SEL-21-02

AIR CONDITIONING - TRANSMITTAL OF KELLY AEROSPACE SERVICE BULLETIN KATS-SB-19-001
RUDDER CABLE CLEARANCE ON CESSNA T206H EQUIPPED WITH KELLY AEROSPACE THERMAL
SYSTEMS AIR CONDITIONING PER STC SA03302CH

Service Bulletin

Rudder cable clearance on Cessna 206H, T206H equipped with Kelly Aerospace Thermal Systems Air Conditioning per STC SA03302CH.

View Looking Up at
Bottom of Airplane

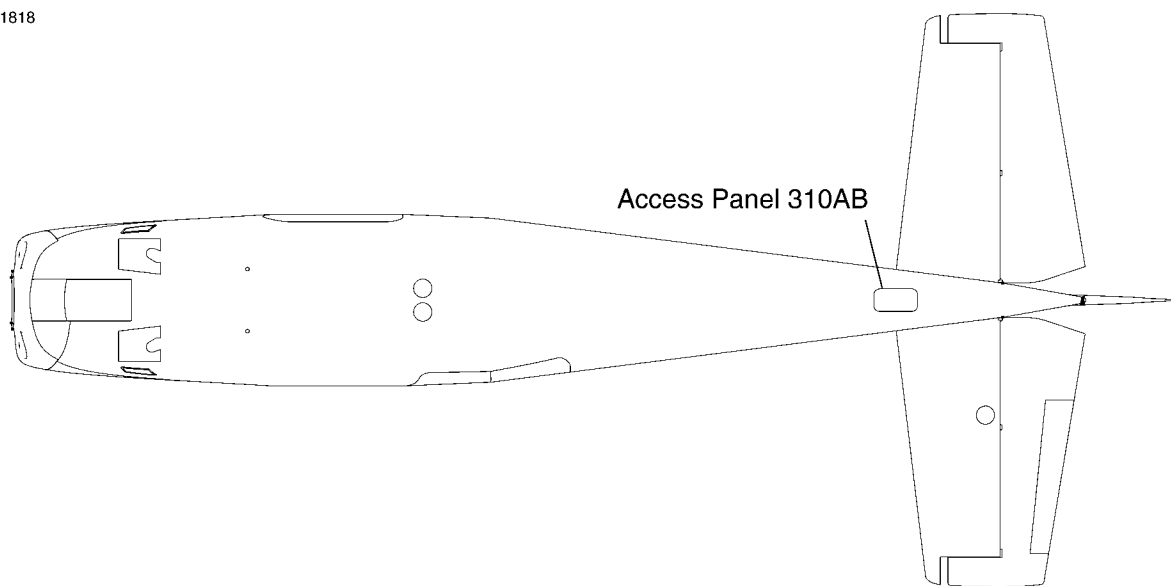
- A. Remove and keep the 12 AN515-8R6 Screws and 1212439-1 Access Panel (310AB) located on the bottom of the tailcone, just in front of the horizontal stabilizer. (Refer to the 206H/T206H Maintenance Manual, Chapter 6, Access/Inspection Plates - Description and Operation, Figure 2.)

Figure 1
Improper Routing of Rudder Cable
Rudder cable is caught between mounting bracket and power stud on circuit board.

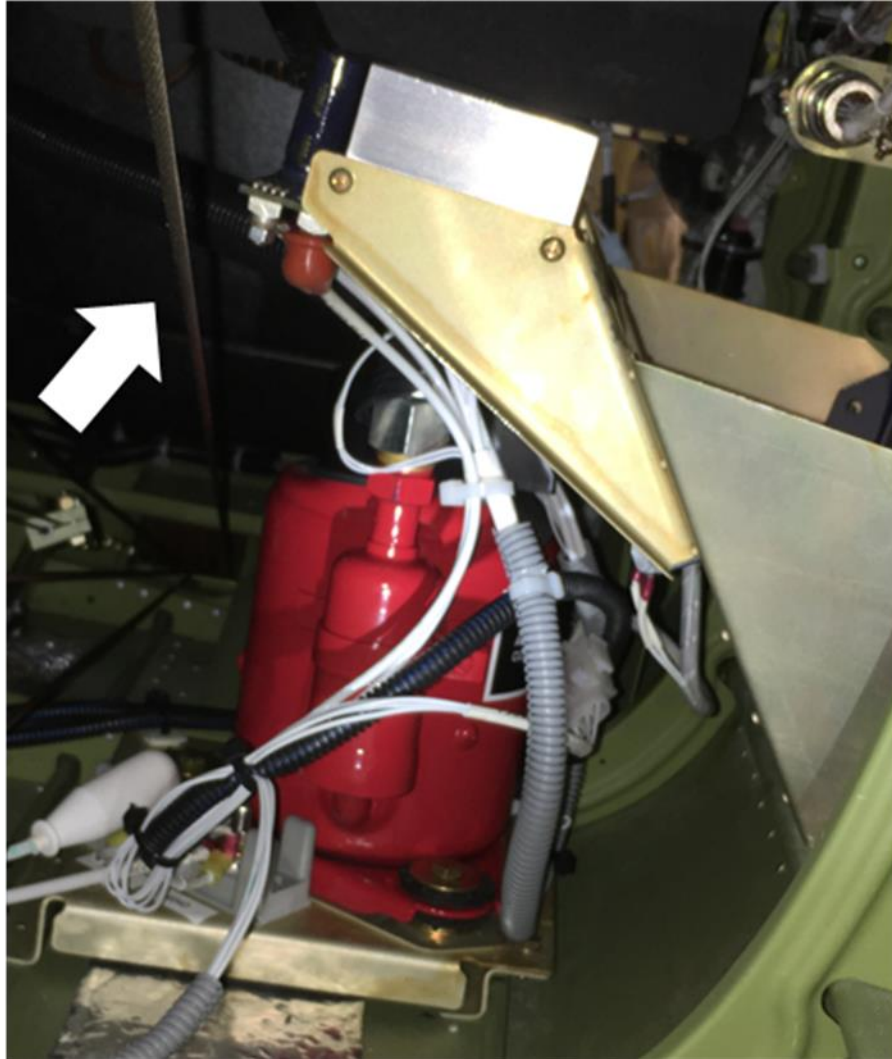
1. Remove access panel number 310AB (P/N: 1212439-1) from bottom of tailcone.
2. Inspect rudder cable routing in tailcone to verify that rudder cable is routed properly, see figure 1 for example of improper routing, see figure 2 for example of proper routing.
3. If the cable is found to be routed incorrectly, the cable routing must be corrected and the cable inspected for damage by a licensed airframe mechanic before further flight.
4. A cover for the control board has been designed to prevent the cable from being caught between the board and bracket and is available upon request from Kelly Aerospace Thermal Systems.
5. This service bulletin is recurring until AC-01995 cover has been installed, inspect per steps 1 & 2 of this procedure each time the air conditioning inlet is removed and reinstalled.
